**RE: Response to Submissions for SSD-46983729 at 1030-1048 & 1050-1064
Mamre Road, 59-62 & 63 Abbotts Road, 290- 308 Aldington Road**

Westlink Industrial Estate Stage 2

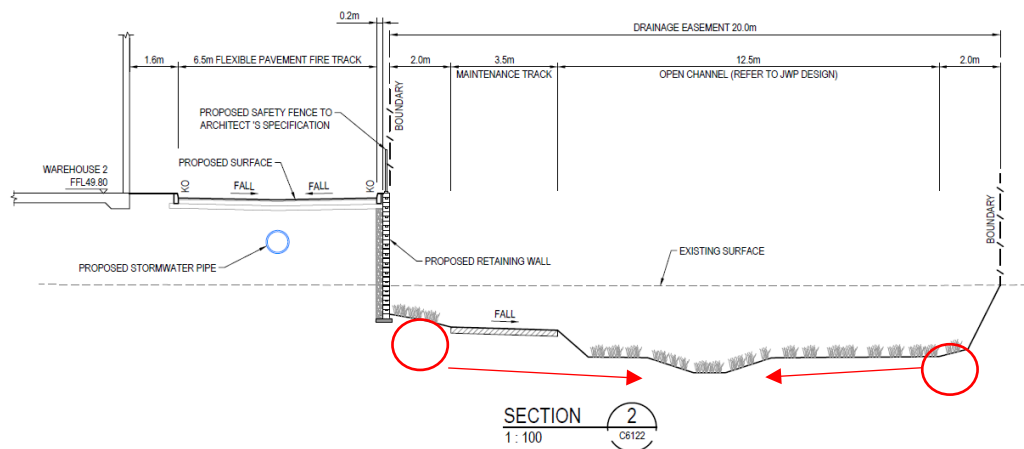
- It has been observed that the on-lot and estate civil drawings and updated water management plan by AT&L, indicate a 20m wide drainage easement, whereas the updated Trunk Drainage Report and drawings by JWP show an 18.9m wide drainage easement. All documentation should be revised to reflect the correct width of drainage easement based on the 2D modelling.

- The on-lot civil drawings show a retaining wall on the northern side of the trunk drainage adjacent to Mamre Road. However, the updated trunk drainage drawings and the flood modelling do not reflect this retaining wall. Please ensure the civil drawings are updated accordingly.

- The trunk drainage section detail in the on-lot civil drawings needs to be revised to align with the 2D modelling and be consistent with the trunk drainage drawings.

- The cross-section detail of the OSD in Lot 2 and its connection to the trunk drainage are inconsistent between the trunk drainage drawing and the on-lot civil drawings. The OSD volume must be designed with the appropriate tailwater condition to the satisfaction of Council.
